20 January 2017

File Number: SSD 6751  
CoS Ref: R/2014/39/E.001

**RE: Modification to Tourism and Visitor Accommodation SSD 6751 – The Sandstone Precinct, 23 – 33 & 35 – 39 Bridge Street, Sydney**

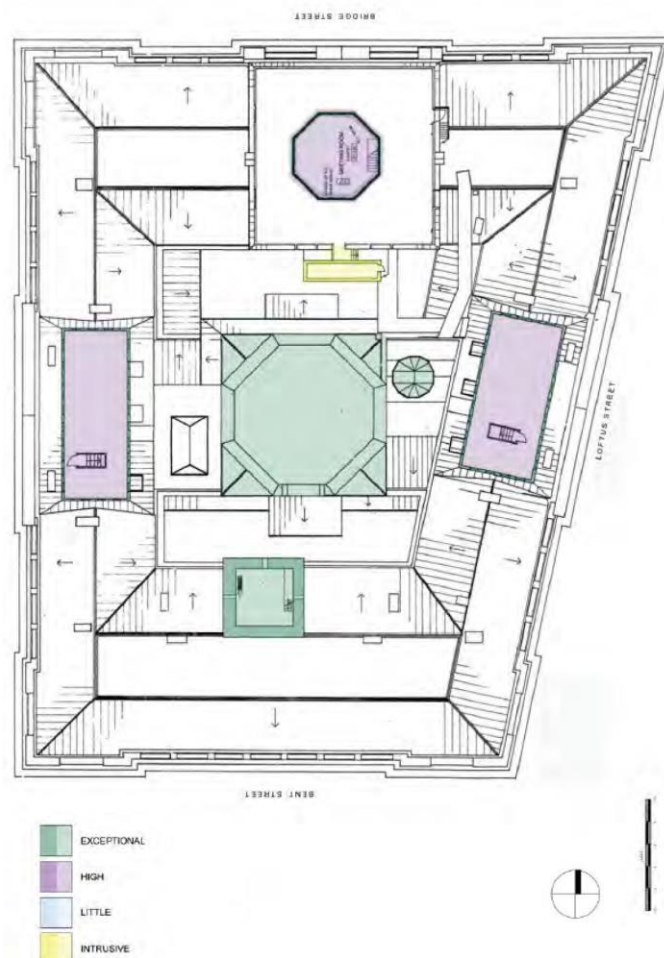
- The physical analysis in relation to the perimeter roofs proposed to be demolished is insufficient. Photographs of the iron roof trusses and the roof spaces proposed to be demolished should be provided in the CMP, along with a condition analysis.
- The roof level significance diagram below (CMP Figure 4.15) does not provide a grading of significance for the roofs proposed to be removed. The roof structure, roof form, railings and roof coverings should be assessed under the NSW Heritage Council Criteria and a grading of significance included in the CMP.
- As there is no grading of significance for the perimeter roofs, it is not possible to determine the applicable policies under the heading 'Treatment of fabric of different grades of significance' on pages 132 to 133 of the CMP.

The image below of an elevated view from a warehouse at the Quay in 1900 shows the primacy of the facades, the towers and the domes:

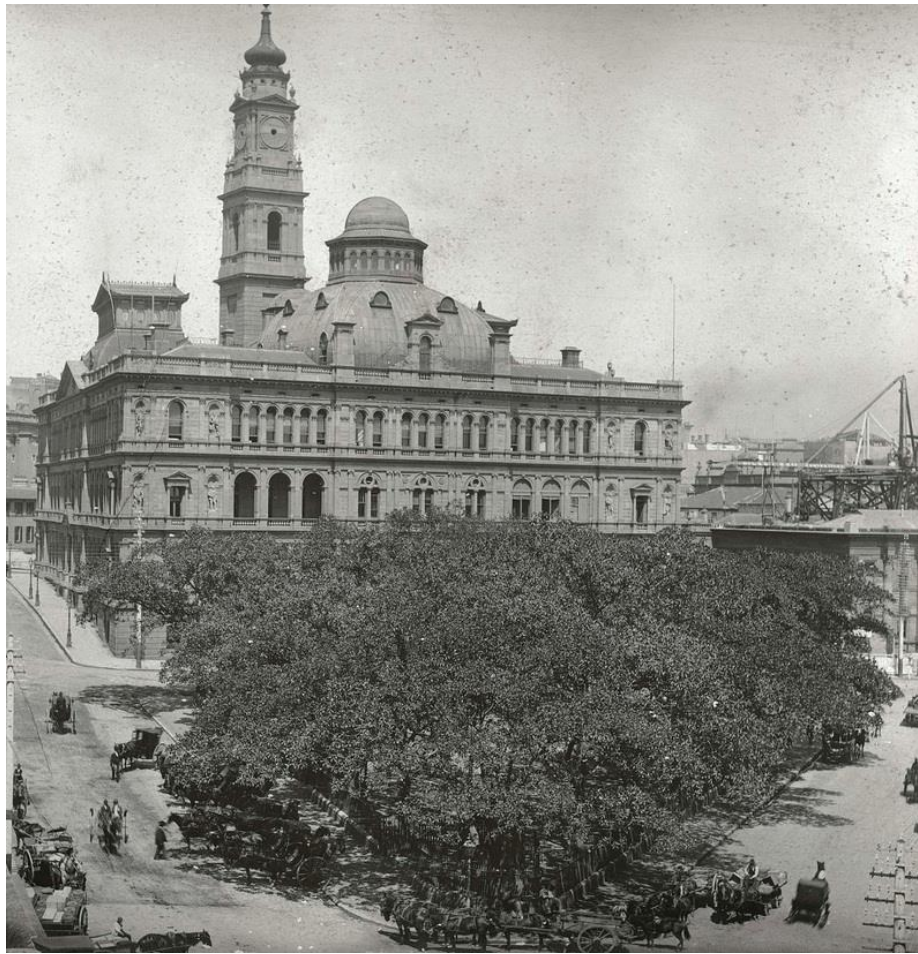
The original perimeter roofs of the Lands Building were intentionally designed to be subsidiary in their nature and their scale so as to afford visual prominence and primacy to the major roof features and to the facades. This was a common architectural device of the Victorian Italianate style, of which the Lands Department is one of the most significant examples remaining in Sydney. They are not 'aesthetically disappointing', but rather they form part of a carefully choreographed hierarchy of forms that express the hierarchy of historic functions within the building.

The City disagrees that 'the subject buildings were originally designed to only be seen from low level but views of their roofscapes are now readily available from the surrounding development' (S of HI, Page 6) The steeply rising land levels of Bridge and Bent Streets have always provided level views to the roofscape of the Lands Department building and these have always been significant views within the streetscapes of Bridge Street, Macquarie Place, Farrer Place, and Bent Street and Spring Street, as well as from Sydney Harbour, the Macquarie St ridge and the Rocks Ridge, particularly prior to the construction of the Education as evident in the image below from Bridge Street, and in the image from Loftus Street further below of the building above a reduced tree canopy in 1928.
